Access Compliance Report

Public Rights-of-Way

Intersection ID: 52487	Main Street: WHITEHALL_EXECUTIVE_CENTER_DR	Cross Street: ORLICK_DR	Location: E
ADA ID: E52E228CAF95	Ramp Type: Perp	Initial Pass/Fail: Fail	Overall Compliance: No
Severity Score: 1.25			
Codes/Mitigation Info/Possible Solution		Field Measurements/Component Compliance

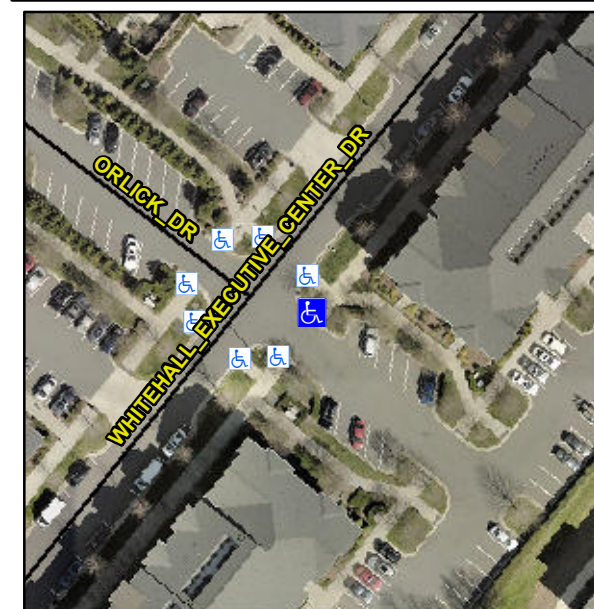
Not Found, R304.5.3

Compliance	Description	Data	Compliance	Description	Data
N/A	Ramp Length (in)	144.0	Yes	Ramp Slope (%)	6.5
Yes	Ramp Width (in)	89.0	No	Ramp XSlope (%)	2.8
N/A	Flare Type LT	N/A	N/A	Flare Type RT	N/A
N/A	Flare Slope LT (%)	N/A	N/A	Flare Slope RT (%)	N/A
N/A	Flare Traversable LT?	N/A	N/A	Flare Traversable RT?	N/A
N/A	Landing Length (in)	N/A	N/A	DWS Provided?	N/A
N/A	Landing Width (in)	N/A	N/A	DWS Contrast?	N/A
N/A	Landing Slope (%)	N/A	N/A	DWS Length (in)	N/A
N/A	Landing X Slope (%)	N/A	N/A	DWS Full Width?	N/A
N/A	Landing Curb? (Y/N)	N/A	N/A	DWS Offset (in)	N/A
N/A	Shared Landing?	N/A			
N/A	Gutter Ponding?	N/A	N/A	Gutter Slope (%)	N/A
N/A	Gutter Lip Ht (in)	N/A	N/A	Gutter X Slope (%)	N/A
N/A	Painted X Walk1?	No	N/A	Painted X Walk2?	N/A
	X Walk 1 Direction	To SW		X Walk 2 Direction	N/A
N/A	X Walk 1 Width (in)	N/A	N/A	X Walk 2 Width (in)	N/A
	X Walk 1 Slope (%)	0.7		X Walk 2 Slope (%)	N/A
	X Walk 1 X Slope (%)	2.6		X Walk 2 X Slope (%)	N/A

Remove & Replace Entire Ramp.
